Docket No. 50-423  
B14108

Millstone Nuclear Power Station, Unit No. 3  
Proposed Revision to Technical Specifications

May 1992

FIGURE 3.1-5

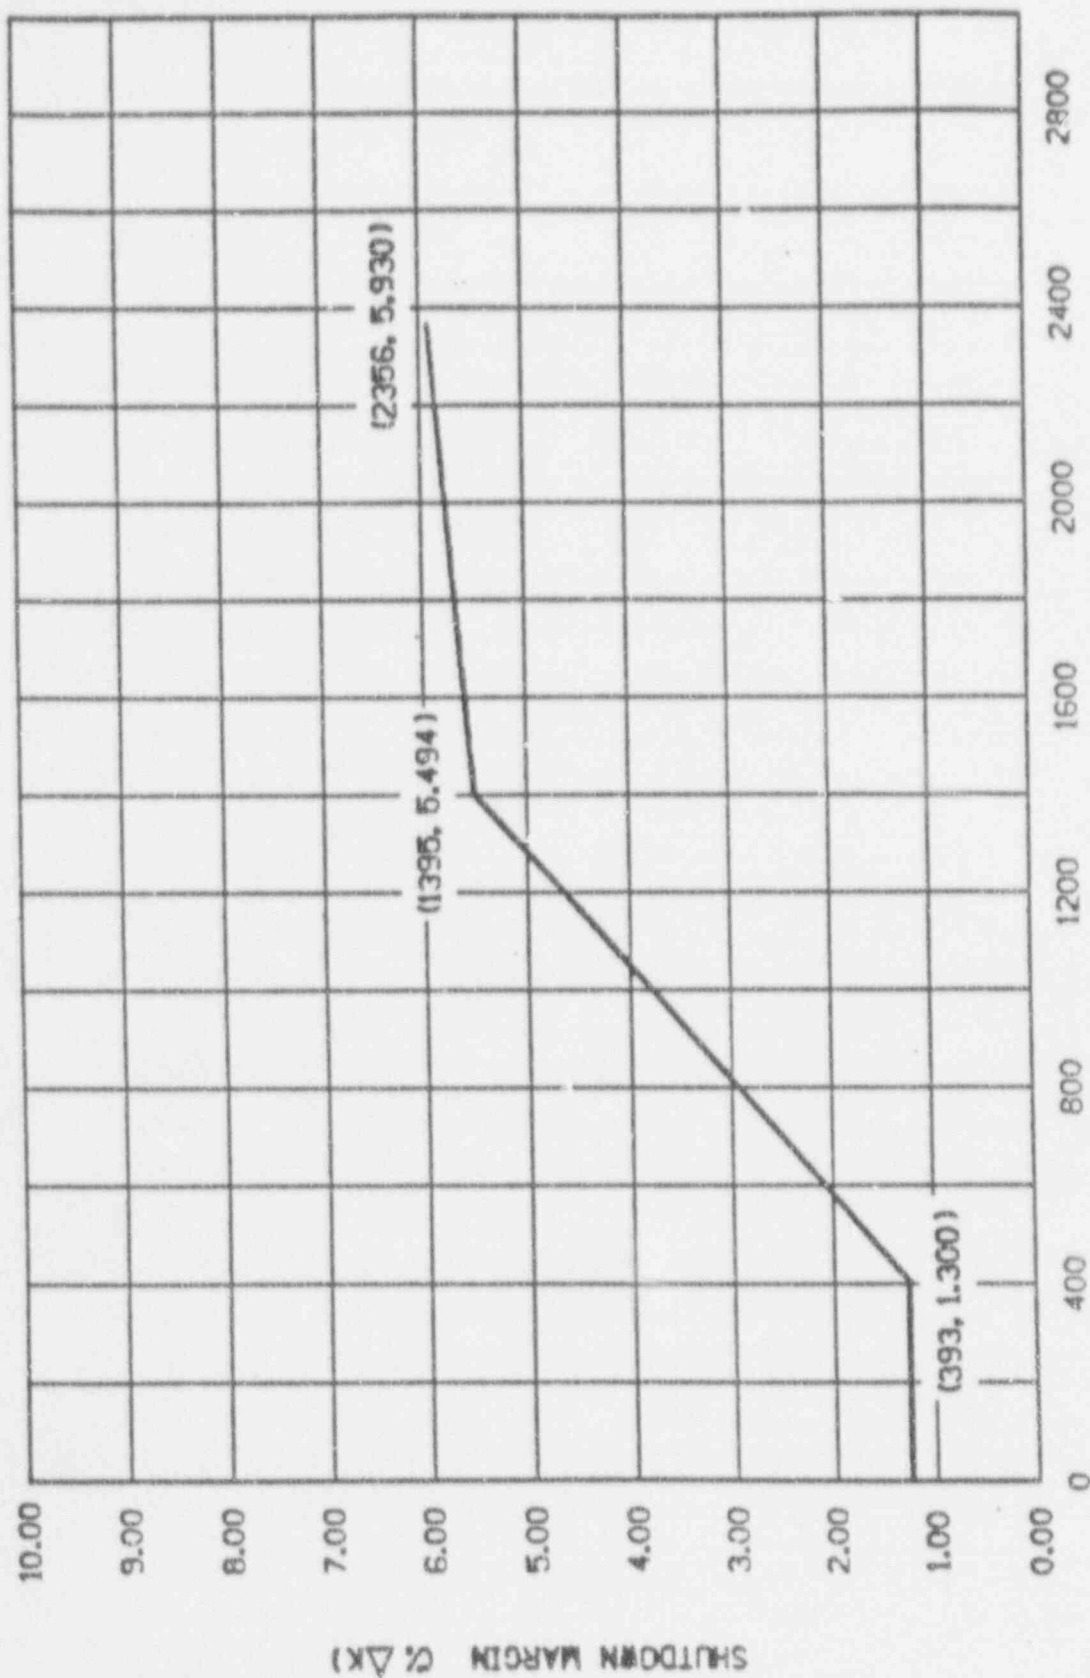
REQUIRED SHUTDOWN MARGIN FOR MODE 5 WITH RCS LOOPS NOT FILLED
